Legalelectric, Inc.

September 6, 2024

RE: NoCapX 2020 - Initial CoN Comment on Merits
MN Energy CON - Lyon Co. to Sherco Transmission Line
PUC Dockets E001/CN-22-131 and E001/TL-22-132

Image 3.2: Xcel Energy's Transmission System in Minnesota, North Dakota, and South Dakota³⁸

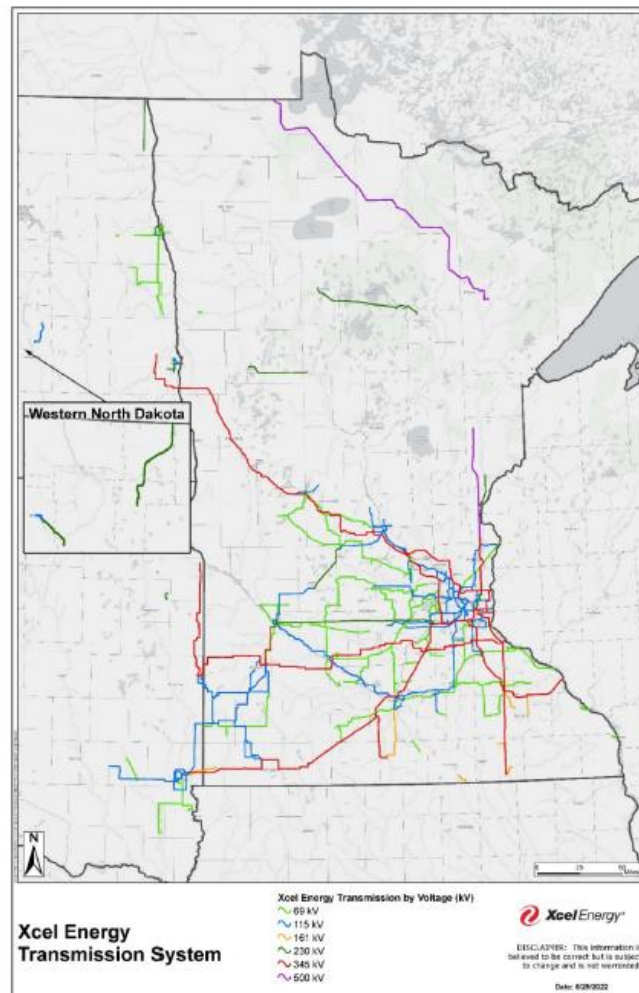
built but not shown on Xcel Energy's map (Application, p. 36). Is it a matter of institutional memory? Many were not present through these projects, and too many were provided grant funding to support the transmission build-out.

Xcel's map, by only including its own transmission (Application, p. 36) is missing transmission relevant to need in southwest and southern Minnesota:

Anyone can see the hole in Xcel's transmission map in southwest Minnesota where it plans to start its Lyon County-Sherco MN Energy CON transmission line. Application, p. 36. However, Xcel's map tells only part of the story – only Xcel's transmission is shown:

Specifically, the Commission must add to Xcel's map (Application, p. 36) the following projects for consideration of their impact on the southwest area of Minnesota, and must also add any other projects having an impact on southwest Minnesota. These have an impact on need:

- **MISO MVP 3, 4, & 5. ITC's MVP 3** :PUC Dockets ET-6675/CN-12-1053; ET-6675/TL-12-1337;
- **Big Stone South-Alexandria-Big Oaks**, PUC Dockets E002, E017, ET2, E015, ET10/CN-22-538;
- **Northern Reliability Project**, PUC Dockets E015,ET2/CN-22-416 and E015,ET2/TL-22-415;
- **Brookings-Lyon Co. & Helena-Hampton Uprate**: PUC Dockets ET-02/CN-23-200 and ET-02/TL-08-1474; and
- **Mankato-Mississippi transmission project, a/k/a Wilmarth-Tremval (WI)**: PUC Dockets E002/CN-22-532 and E02/TL-23-157.

**Figure 1: Big Stone South – Alexandria – Big Oaks
345 kV Transmission Line Project**

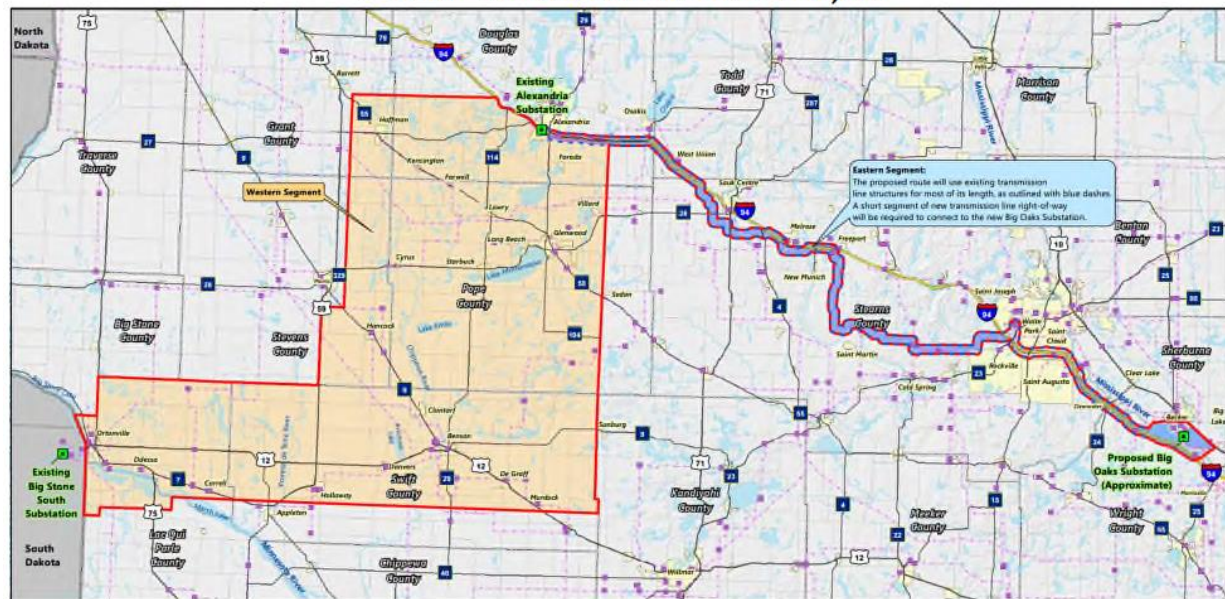
The Commission must consider need the transmission line proposed in light of the application for a transmission line from Big Stone to Alexandria to Big Oaks, essentially from the Lyon Co. area to the Sherco area. Yes, Big Stone is near Lyon County, proposed for the start of MN Energy CON. Why another? For some reason, no commentor other than NoCapX has raised this project, which could connect to Sherco substation, in relation to the MN Energy CON line, and could/would have an impact in loading in southern Minnesota and the Sherco substation. See

PUC's Big Stone South-Alexandria-Big Oaks, Docket E002, E017, ET2, E015, ET10/CN-22-538:

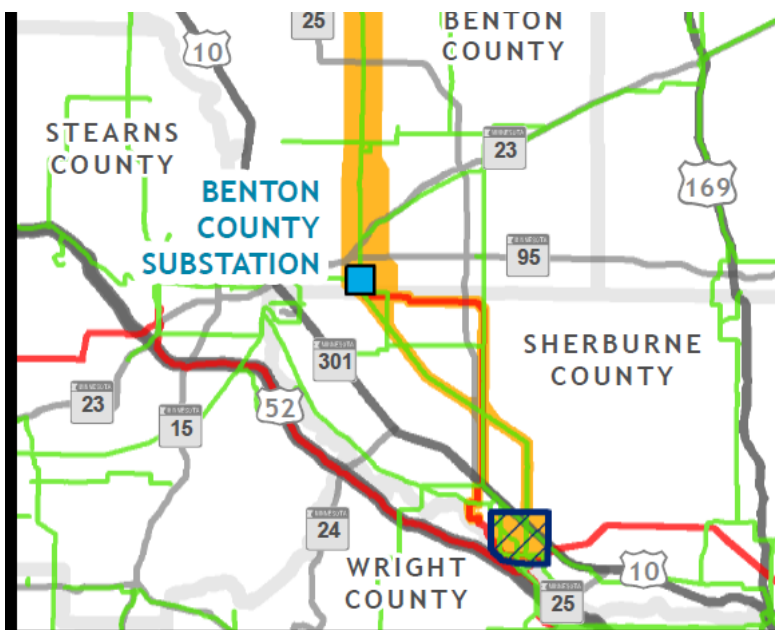
The Northern Reliability Project, E015,ET2/CN-22-416 and E015,ET2/TL-22-415, which runs from the Itasca County substation near Grand Rapids down to the “Big Oaks” substation near Sherco. For some reason, only NoCapX 2020 has raised the current transmission projects in the area, and this is yet another project that could interconnect at Sherco:

Figure 1

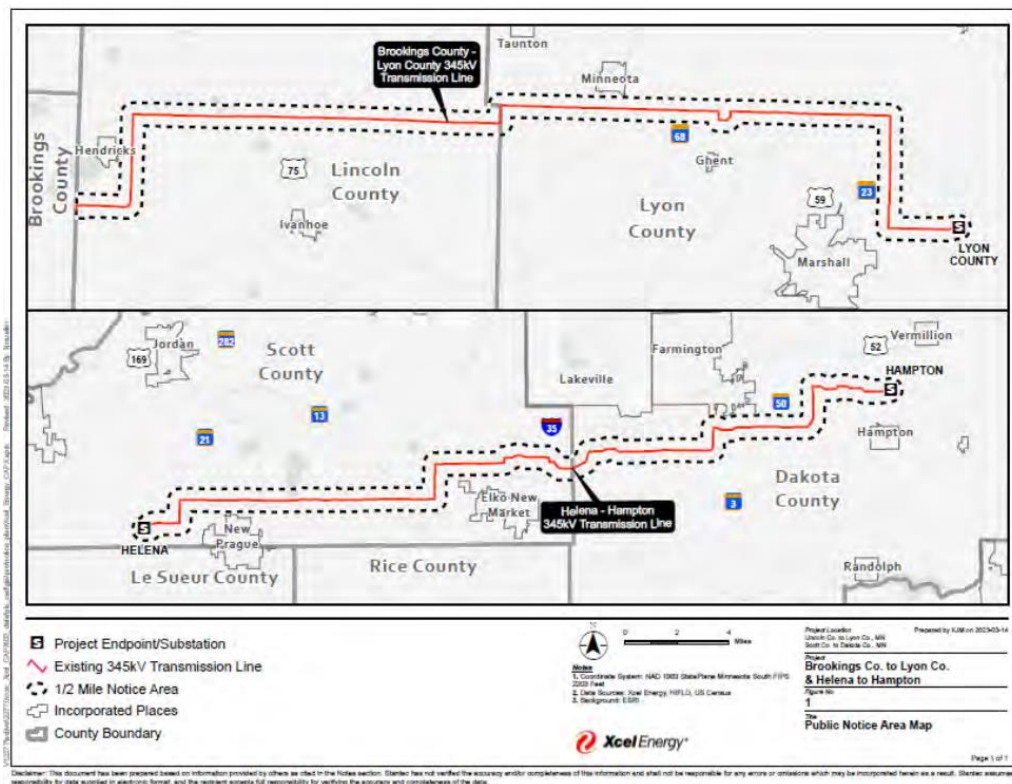
Xcel is double-circuiting two portions of its “Brookings-Hampton” CapX 2020 transmission project. No CapX 2020 was an initial intervenor in this docket, ET-2/TL-08-1474, together with United Citizens Action Network (U-CAN). See also ET-02?CN-23-200. This transmission uprate will increase capacity out of Lincoln and Lyon Counties. Again, for some reason, no commenter other than NoCapX 2020 has referenced this uprate, which logically has an impact on transmission loading in southern Minnesota and transmission to the metro and points east.

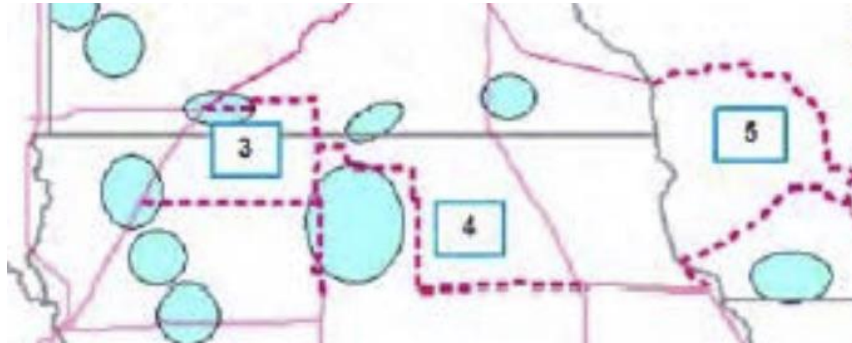
Xcel fails to include significant and relevant transmission existing in southern Minnesota that is available for generation in southwest Minnesota – the ITC transmission, MVP projects 3, from Lakefield Junction to Huntley in Minnesota, to Ledyard and Kosseth County substation in Iowa:

In considering need for Xcel's MN Energy CON, the ITC lines MVP 3 and 4 in Minnesota and into Iowa, and MVP 5, the northern part known as Badger Creek/CapX 2020 from La Crosse to North Madison, and the southern part known as Cardinal-Hickory Creek, going across the Mississippi towards Madison.

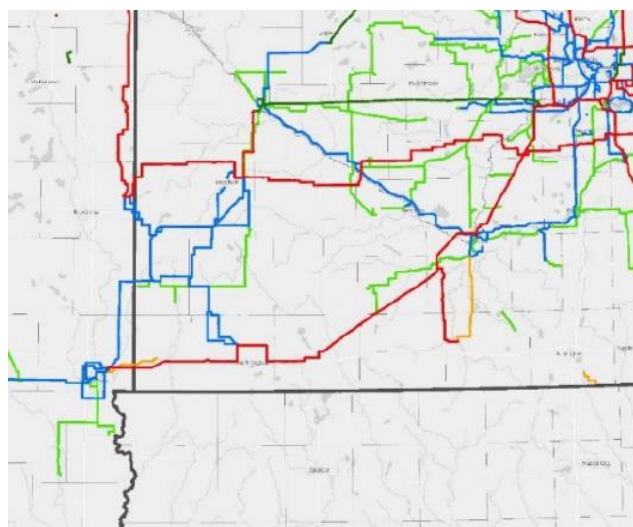
F. ANY NEED CONSIDERATION CAN ONLY BE MADE IF THE FULL RANGE OF EXISTING AND PROPOSED TRANSMISSION PROJECTS IN AND AROUND SOUTHWEST MINNESOTA ARE DRAWN ON THE MAP!

Xcel's transmission does not exist in a bubble. As we say in transmission, "It's all connected!" As above, the Commission must start with that Xcel map and add the existing ITC lines, MVP projects 3, 4 and 5, which draw energy out of southwest Minnesota and consider the impact on capacity. The Commission must also consider all those transmission projects now before it that have an impact on the transmission system and transmission capacity. The Commission must draw existing projects not owned by Xcel on the map, must put these applied for projects on the map, and consider the impact of all these lines on transmission capacity. Xcel is revealing only part of the picture.

Figure 3-2: NSP System Median Base Summer Peak Demand (MW)
(Includes modeled EE Adjustment)

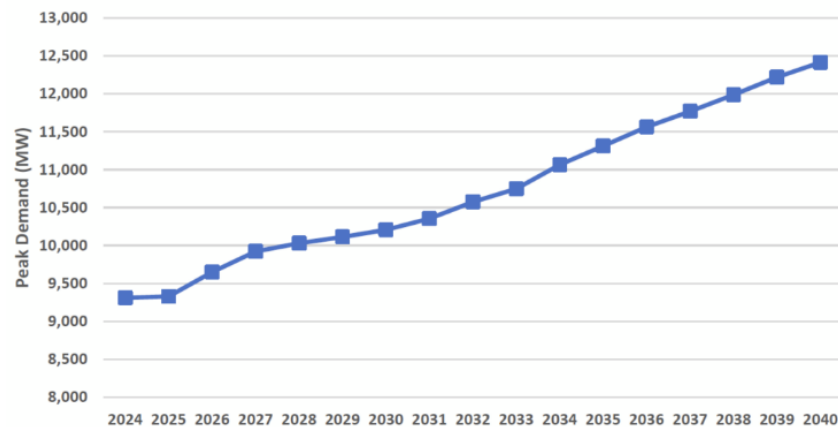
What demand projection? Look at Xcel's convenient claim of an annual 1.8% increase in peak demand, as of its just filed Integrated Resource Plan, PUC Docket RP-24-67. It contains a chart

that is eerily reminiscent of the grossly overblown CapX 2020 demand projections of 2.49%, see IRP Chapter 3, page 2 of 29:

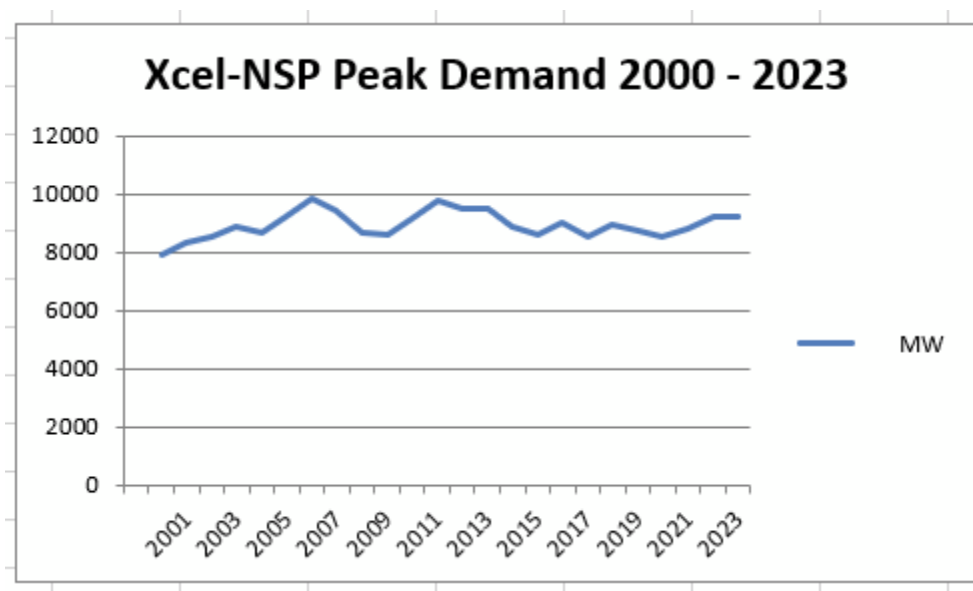
That IRP projection is laughable, and hopefully not taken seriously by the Commission. Referring to their CapX peak demand projections as “grossly overblown” is not hyperbole. Here is their peak demand as taken from the Xcel Energy 10-K filings with the SEC:
